MILITARY SPECIFICATION

INDICATOR, COMBUSTIBLE GAS TOXIC GAS

This amendment forms a part of Military Specification MIL-I-38715A(USAF) dated 5 December 1968.

FIGURE 3 -. PERFORATED EXTENSION TUBE ASSEMBLY

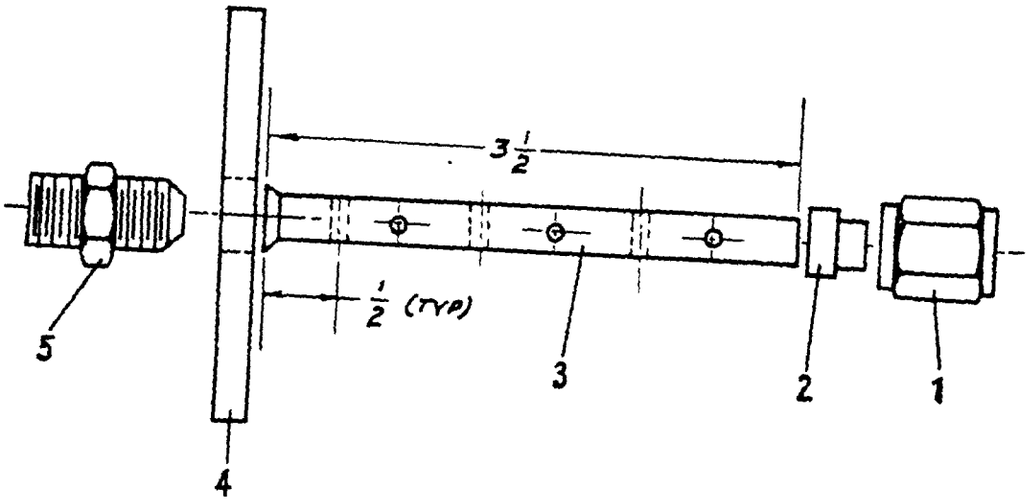
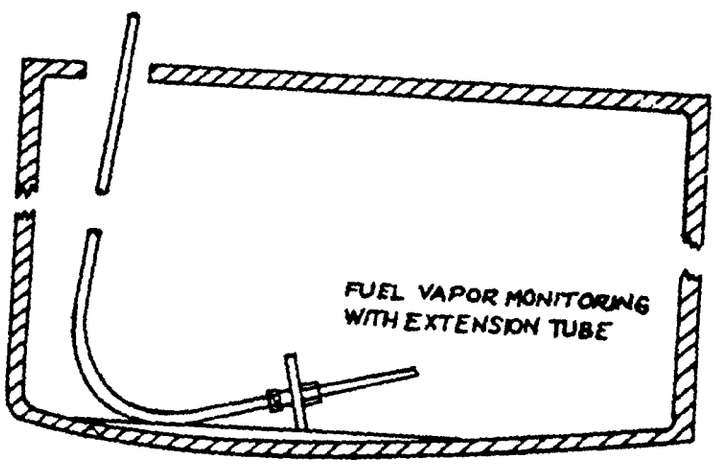
3 6.13 Delete and substitute

"3.6.13 Extension tube. A perforated nylon tube shall be supplied with each unit to prevent the end of the sampling hose from being immerged in fuel (see Figure 3)."

Add: "Figure 3" which is page 2 of this amendment.
